NC-107 Report

NOVEMBER 2019

ASHEVILLE DESIGN CENTER

Several of the Asheville Design Center consultant team members, from Traffic Planning & Design and Friction Shift Projects, reviewed the NCDOT preliminary plans for NC-107 (Titled: 'R5600_RDY_PRELIMINARY_DESIGN_MAP', Dated: January 2019). Our review of the NCDOT preliminary designs for the intersections of NC-107/US-23 and NC- 107/Webster Road yielded several pedestrian and bicycle safety related treatments for consideration at these intersections. The team formulated these recommendations with key goals in mind, which were informed by the community engagement portions of this project:

Figure A: NC-107 at US-23 Intersection Shown with References to this Memo.

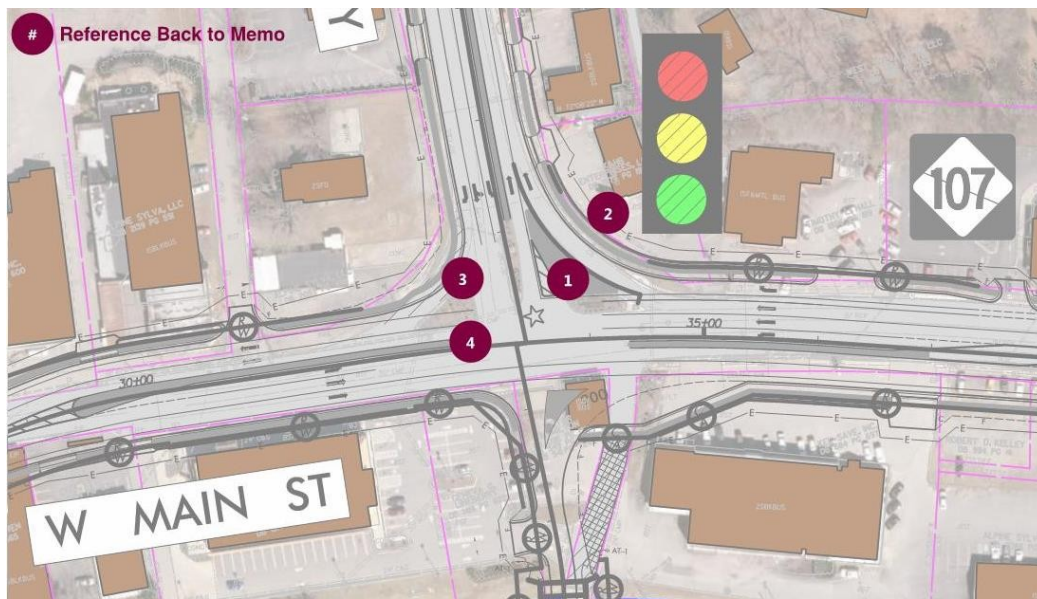
Vertical Traffic Calming Elements: For visual location of the following references, see Figure A.

- Consider reconfiguring the island at Location #1 in Figure A: The NCDOT preliminary design accommodates relatively high travel speeds for the free flowing right turn movement from NC-107 onto US-23 Business northbound. It may be feasible to reconfigure this right turn design to slow traffic for pedestrian safety purposes. As shown in the attached resource from University of Texas, there are several compound radius alternatives that encourage slower speeds and increase pedestrian visibility. Additional benefits and considerations to this design are as follows:

- Reconfiguring the island would also provide a pedestrian refuge, reducing pedestrian exposure and potentially calming traffic. Under this scenario, this island would require pedestrian signals with properly placed accessible push buttons.

- Alternate channelized right turn designs could potentially reduce the right-of-way impact, pending further vetting in design (See Figure A, Location #2).

- Consider adding an island (Figure A, Location #3) at the northwest corner of the intersection: There may be an opportunity to add a pedestrian refuge island at this location. This could present an opportunity to reduce pedestrian crossing distances and provide space for pedestrian signal equipment.

- Consider extending median for pedestrian refuge area (Figure A, Location #4): The design team identified this median for further investigation. This extension could provide a small pedestrian refuge area and could calm traffic as it would require slower turning speeds.

Figure B: NC-107 at Webster Road Intersection Shown with References to this Memo.

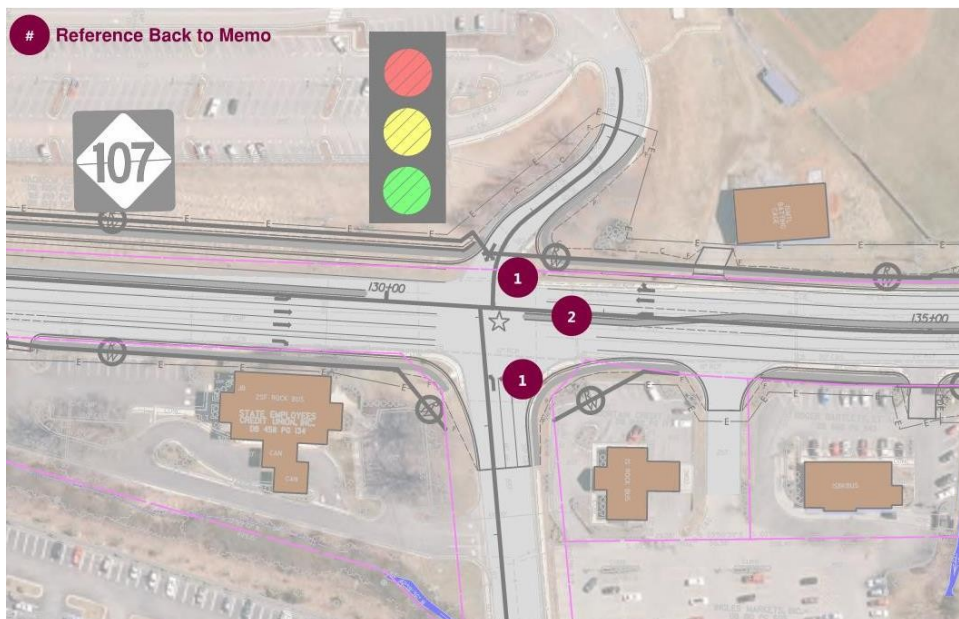
Vertical Traffic Calming Elements: For visual location of the following references, see Figure B.

- Consider adding an island: At the southwest and southeast corners of the intersection (See Figure B, Locations #1), there may be an opportunity to add pedestrian refuge islands. The recommendation could help shorten pedestrian crossing distance and reduce pedestrian exposure to traffic.

- Consider a two-stage crosswalk (See Figure B, Location #2): The pedestrian crossing distance on the southern leg of NC-107 is wide and has a skewed crosswalk alignment from Webster Road to Alexander Street. Further investigation into a two-stage crossing is recommended for several reasons:

- This design option would allow for better crosswalk orientation (closer to 90 degrees) for visually impaired users
 - Enhanced pedestrian safety with a two-stage crossing and pedestrian refuge island

For this option, the pedestrian refuge island would need to be a minimum of 8 feet wide and would require pedestrian channelization fencing to prevent jaywalking. Photo 1 shows an example of a two-stage crosswalk from FHWA's webpage.
